STAFF RECOMMENDATION

1302 Calvin Avenue

Application: New Construction—Addition

Description of Project: The application is to construct a new rear addition to a one-story historic house.

Figure 2: Proposed front elevation

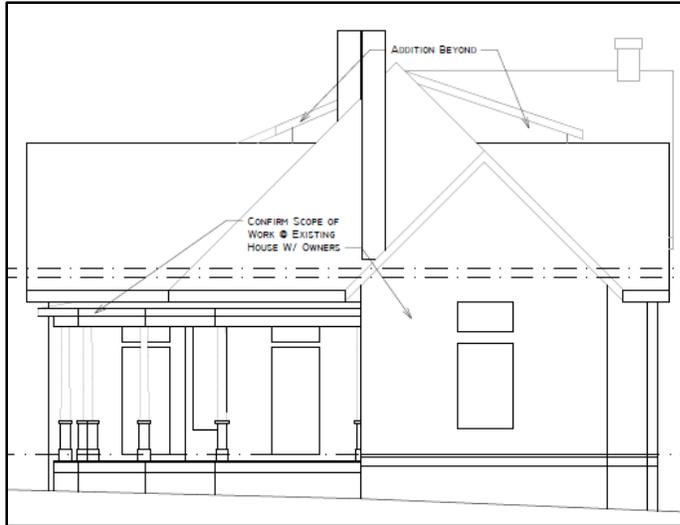
Design, Location & Removability: The location of the addition at the rear of the existing building is in accordance with the design guidelines. The addition ties into an existing non-contributing rear addition, and is differentiated from the existing structure by setting in at least one foot, six inches (1’6”) from the existing rear corners. At the same time, its scale, materials, roof form, and fenestration pattern are all compatible with the existing house.

As described above, the proposed addition is both shorter and narrower than the historic house, however, due to the design and location, portions of the addition will be visible from the front façade. Although the addition is shorter than the peak of the historic house, the original structure has a hipped with cross-gabled roof form. Thus, the peak of the hipped portion of the roof projects about seven feet (7’) higher than the cross-gabled portions. The addition uses a rear and side gabled roof, with a shed roofed portion as well. These new roof forms are lower than the peak of the hip, but will be visible above the historic side gabled portions. Staff finds that because the additional roof forms sit below the ridge and because the highest portions are significantly setback from the front elevation, the design and location of the roof forms is appropriate.

Figure 3: Proposed east elevation

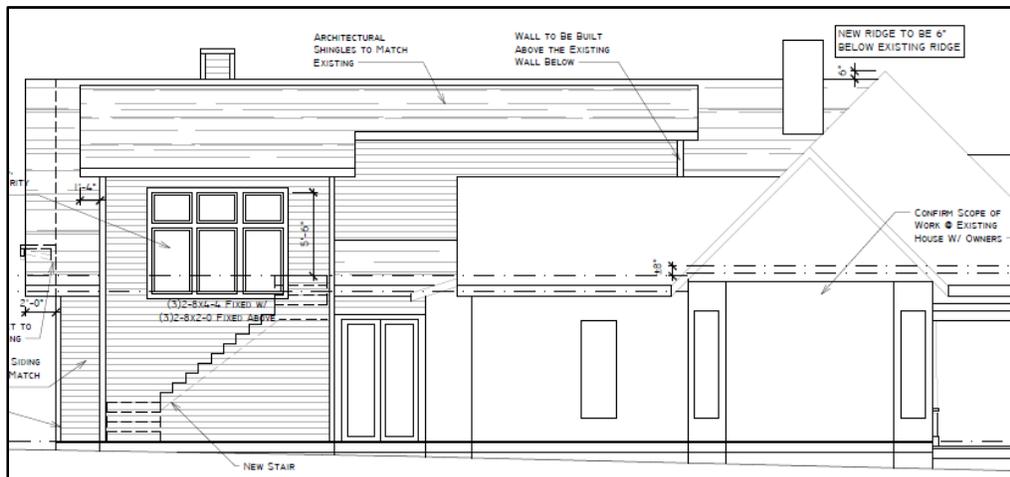
On the east elevation, the addition incorporates a two-story shed roofed portion which houses the stairs. The eaves on this portion of the addition are about seventeen feet (17’) tall, while the eaves on the historic house are about ten feet (10’) tall. The taller eave height could be

appropriate in this location, because the ridge height is still less than the historic ridge, because the taller portion is about fifty-five feet (55') behind the front façade and because the taller portion is inset seven feet, five inches (7'5") from the historic side wall.

Figure 4: Proposed west elevation

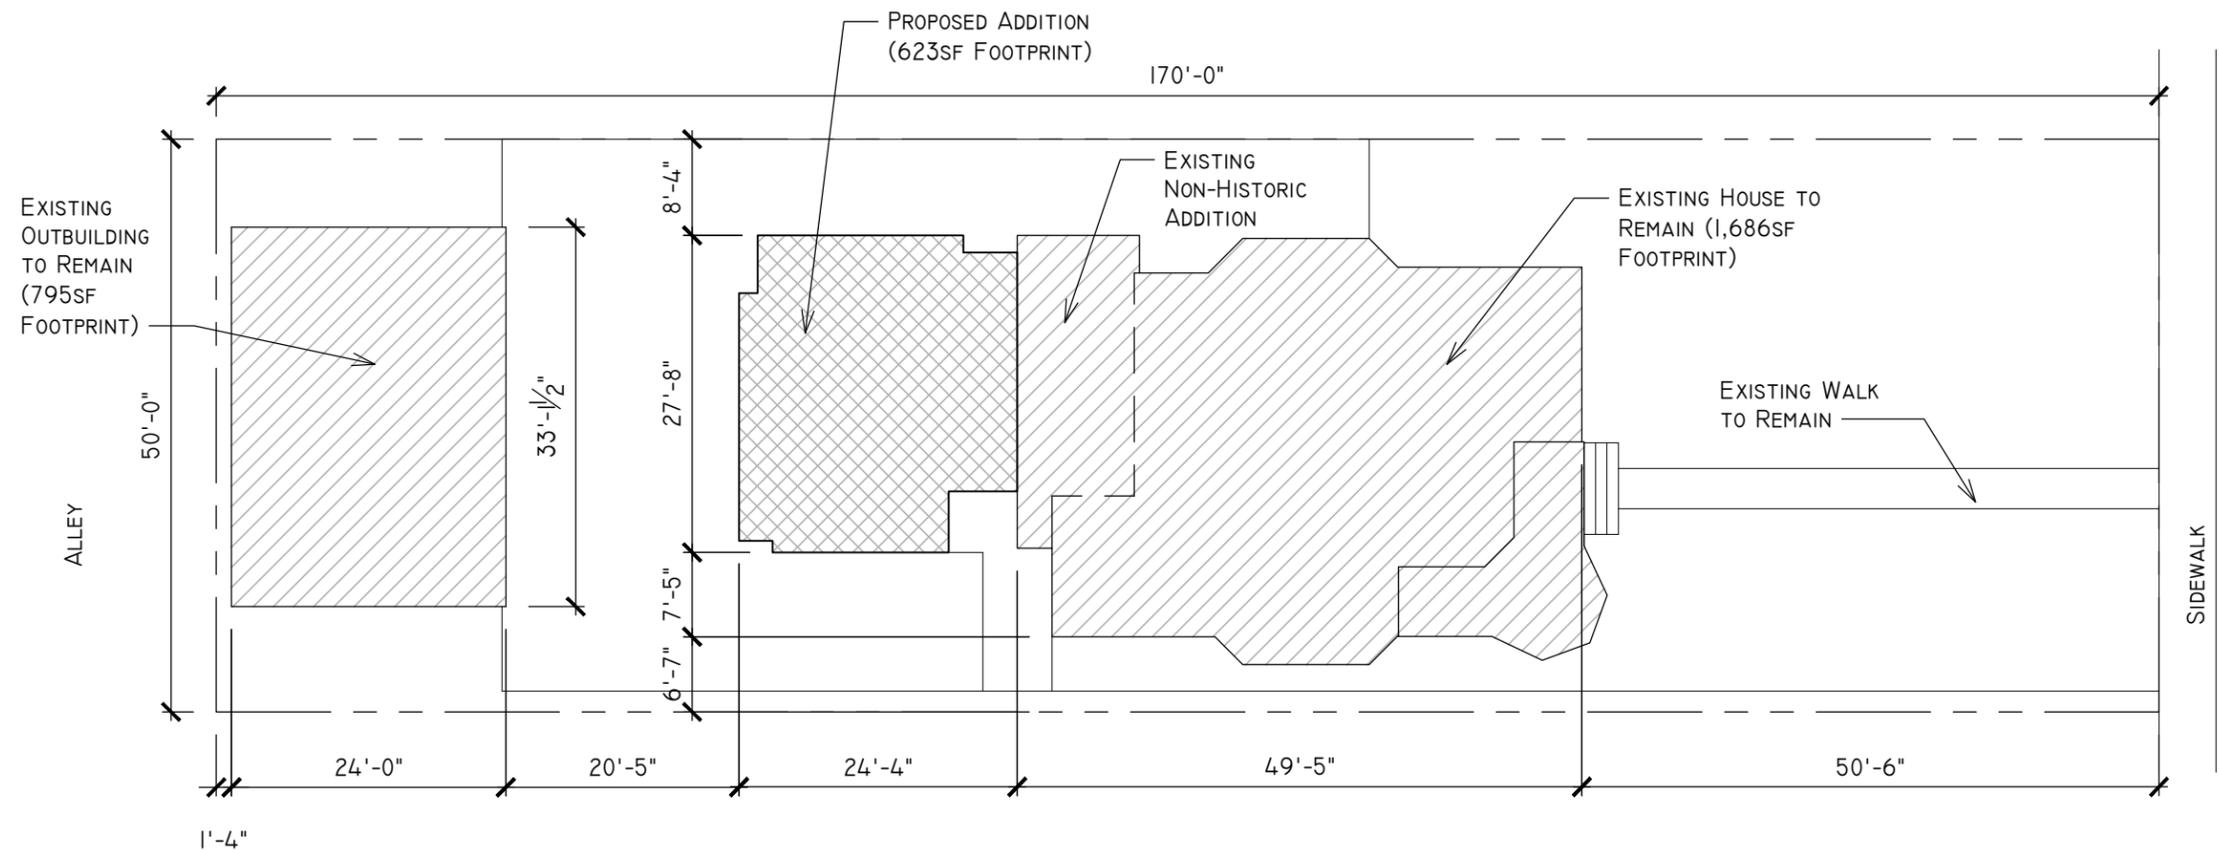
The west elevation has a dormer that is appropriately glazed and appropriately inset from the wall below. There is also a one-and-a-half story side gabled projection. Again, the ridge height is lower than the peak of the historic hipped roof. On this elevation, due to the gabled roof form, the eave heights measure just over twelve feet (12'), as compared to the eave heights of the historic house which are about ten feet (10'). Staff finds that this higher roof form could be appropriate because it is still lower than the historic ridge, because it is the same slope as the historic roof and because the ridge is set back more than sixty feet (60') from the front of the house.

Staff is concerned because the two story portion of the addition does not inset two feet from the historic side wall of the house. The Commission has agreed to review two-story additions to one-story houses on a case-by-case basis, and to determine the appropriateness of inseting such additions by reviewing the circumstances of each case. This addition ties into the existing non-historic addition using a one foot, six inch inset for a four foot, eight inch (4'8") distance. Then it steps back out flush to the non-historic side wall – which is also flush with the historic side bay window. For the addition to inset two feet (2') from the historic side wall itself, it would need to step in about another five feet, three inches (5'3"), which would significantly impact the square footage.

Staff finds that the lack of inset could be appropriate in this instance for several reasons. Additions to hipped roofs are difficult to accomplish without some visibility. The side-gabled design of this addition is compatible with the cross-gabbling of the historic house, and allows for the eaves to be pulled low, to within a couple feet of the historic eave height. The addition is set back significantly from the front wall and does not attach directly to any original portion of the house.
